**RE: Response to EPA Comment Letter dated December 7, 2006  
Five-Year Review Report – April 2006  
Recommendation #9–Redevelopment/Sampling of Surficial Aquifer Wells  
Cabot Carbon/Koppers Superfund Site in Gainesville, Florida**

**Attachment A**  
**Response to EPA Comment Letter Dated December 7, 2006**  
**Five-Year Review Recommendation #9**  
**Redevelopment/Sampling of Surficial Aquifer Monitoring Wells,**  
**Cabot/Koppers Superfund Site, Gainesville, Florida**

**Figure 1. Locations of Surficial Aquifer wells proposed for sampling and redevelopment at the Cabot Carbon/Koppers Superfund Site.**

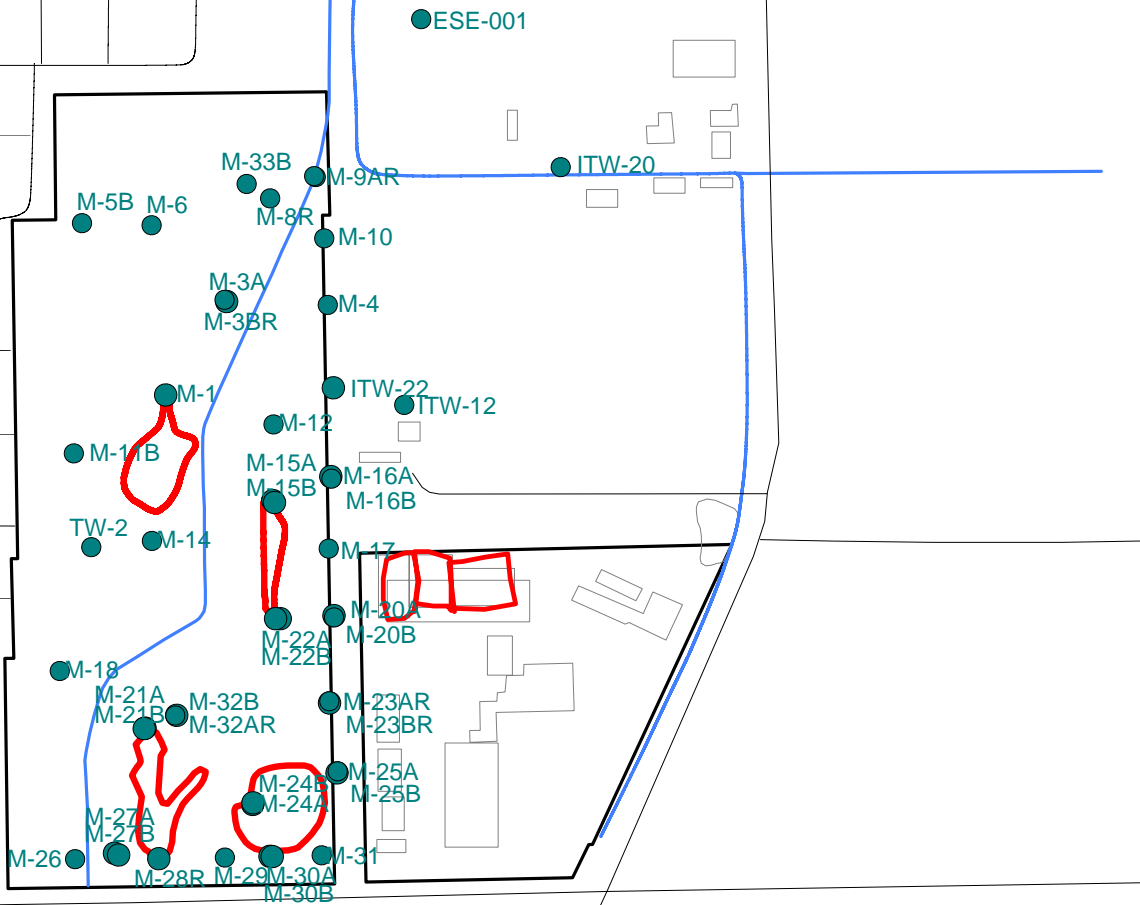
**Comment 2:** *For wells on the Koppers property within or close to contaminant source areas or suspected principal source areas, EPA requests that the wells be redeveloped and monitored. Any observations of free product in those wells (determined from pre-redevelopment investigations or observed during actual sample collection) should be noted. Such observations will be a consideration in the evaluation of analytical data (EPA acknowledges that the presence of NAPL in a sample makes a dissolved-phase concentration of at least organic contaminants suspect or invalid). EPA considers this source-area sampling to be important for the following reasons:*

**Comment 6:** The following comment was received from Gainesville Regional Utilities: Beazer's October 30, 2006, response to Recommendation #9 - Redevelopment/Sampling of Surficial Aquifer Wells appears to focus on creosote constituents only. That conclusion is based on the proposal to exclude sampling wells located near source areas because "Monitor wells completed in the former source areas are not representative of the dissolved-phase plume for the Surficial Aquifer and are likely impacted by residual NAPL droplets and sheens in the well". In addition to creosote constituents, the dissolved arsenic plume should also be a major focus if the well redevelopment and sampling plan. Therefore, to provide data within the central portion of the Superfund site, and at two or more potential sources of arsenic contamination where data are currently lacking, it is recommended that (at a minimum) the following Surficial Aquifer wells (as presented on Figure 1 of the October 30, 2006, Beazer letter) should be added to the list of wells to be redeveloped and sampled:

- *Well at the north end of the Former North Lagoon;*
- *Wells at the north and south ends of the Former South Lagoon;*
- *One well at the north end and one well at the south end of the Former Drip Track;*
- *One of the wells between the south end of the Former South Lagoon and well M-26; and*
- *Three wells within or adjacent to the Process Area: (1) one well at the southern boundary, (2) one well in the central-portion of the source area, and (3) one well near the northwest boundary.*

We agree to add monitoring wells located on the periphery of the source area boundaries. The following Surficial Aquifer wells will provide sufficient analytical data to assess COC concentrations in the vicinity of the former source areas:

- 1) Former South Lagoon: M-28R, M-21A and M-21B;
- 2) Former North Lagoon: M-1;
- 3) Former Drip Track Area: M-15B, M-22A and M-22B; and
- 4) Former Process Area: M-30A, M-30B, M-24A and M-24B.

**Response:** See response to Comment #2. In addition, monitoring wells M-27A and M-27B have been added to the list of wells to be redeveloped and sampled as part of this program.
